# UNITED STATES PATENT AND TRADEMARK OFFICE

APPLICATION NO.	FILING DATE	FIRST NAMED INVENTOR	ATTORNEY DOCKET NO.	CONFIRMATION NO.
10/538,809	12/23/2005	Christophe Mathoulin	0573-1020	5678
466	7590	10/04/2006	EXAMINER	
YOUNG & THOMPSON 745 SOUTH 23RD STREET 2ND FLOOR ARLINGTON, VA 22202			WOODALL, NICHOLAS W	
			ART UNIT	PAPER NUMBER
			3733

**Office Action Summary**

Figure 1

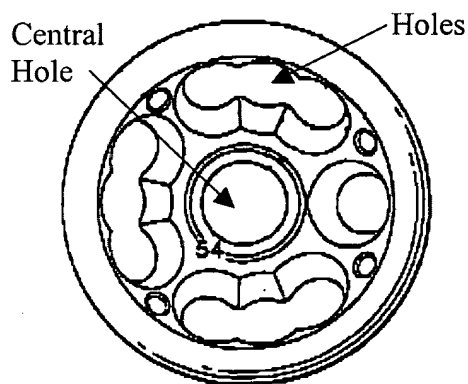
Regarding claim 1, Huebner discloses a device comprising lateral holes and a flat face (reference Figure 1 below). The holes are at an angle to direct the screws

towards the outside edge of the plate. Huebner shows various embodiments of the device, one including a flat face that contacts the surface of the bone. Regarding claim 2, Huebner further discloses a device that is circular in shape. Regarding claims 3 and 4, Huebner further discloses a device wherein the upper face comprises a recess (claim 3). The recess occupies a majority of the upper face of the device and is the form of a hollow spherical cap (claim 4). Regarding claim 5, Huebner further discloses a device further comprising at least one screw hole in the form of a hollow spherical section and a screw with a matching head to allow a multidirectional orientation of the screw (reference Figure 2 below). Regarding claim 6, Huebner discloses the device further comprising a number of holes close to the number of bone being treated. In one embodiment, Huebner shows a device comprising four holes to allow screws to pass into four different bones.
